City of Alexandria, Virginia

MEMORANDUM

SUBJECT: CONCEPT REVIEW OF 101 DUKE STREET

BAR CASE # 2020-00612

Figure 2: Site plan for proposed townhomes

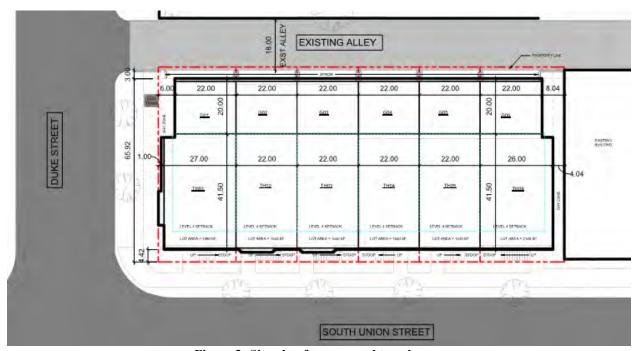
The applicant is proposing to build six four-story townhomes facing South Union Street with attached garages having access from the alley to the west of the site (figure 2). Townhouse one is 27' wide by 41-6" deep, townhouse two through five are 22' wide by 41'-6" deep, and townhouse six is 26' wide by 41'-6" deep. A single story 22' wide by 20' deep attached two-car garage with rooftop terrace is located at the west side of each townhome. The grade along South Union Street slopes from a high point at the south end of the site to a lower point at the north end of the site. Each of the townhomes has a height of approximately 50' above the average finished grade. Due to the slope along South Union Street the height of the first floor above the sidewalk ranges from 5'-3 34" at townhouse one to 6'-9 34" at townhouse 6.

Figure 5: East-west section through site indicating elevation difference between alley and South Union Street

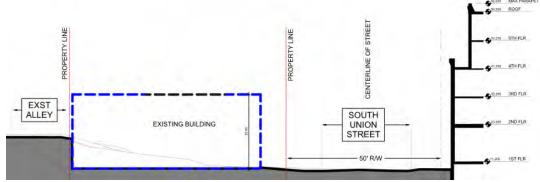
An important factor to be addressed in the design of this project is the relationship between the grade along the alley to the west side of the site and the grade along South Union Street. The southeast corner of the site is 3' higher than the northeast corner over the course of the 145' length of the site. The southwest corner of the building is 4' higher than the southeast corner and the northwest corner is 10' higher than the northeast corner. The result of this grade differential is that the rear of the site where vehicular access is located is significantly higher than the sidewalk on South Union Street (Figure 5 & 6).

Figure 6: Diagram showing grade elevations around perimeter of site

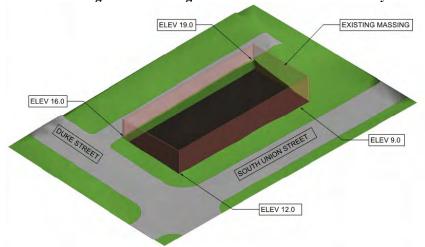
In addition to the challenges posed by the changes in grade, the east edge of townhouses 5 and 6 are within the flood plain which is approximately 12" above the elevation of the sidewalk. Per the City Zoning Ordinance, no residential use can be located below this elevation within the flood plain.

Figure 7: Typical townhome section

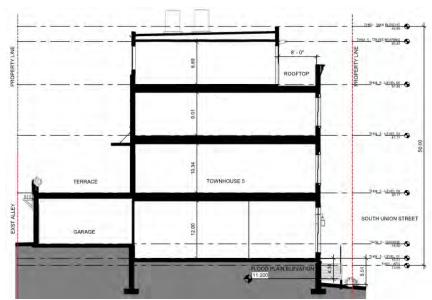
The proposed design includes attached garages with rooftop terraces and vehicular access from the alley to the west of the site. In order to allow for access to the terraces and to locate windows at the second floor of the west elevation, the applicant has fixed the second-floor level at the level of the roof of the garages (Figure 7). Because of the elevation of the alley this then places the second floor, likely to be the main living space, well above the sidewalk on South Union Street than would typically be found in residential development. This results in the first floors for each townhome that are taller than usual and entry stoops that are higher above sidewalk than those found throughout the district. The first floor of units 2-5, while likely to be interesting spaces with high ceilings, will have limited natural light. This relationship not only poses a difficulty to designing the first floor fenestration with a proportion that is compatible with buildings in the district, but also creating a comfortable relationship between the townhomes and the sidewalk.
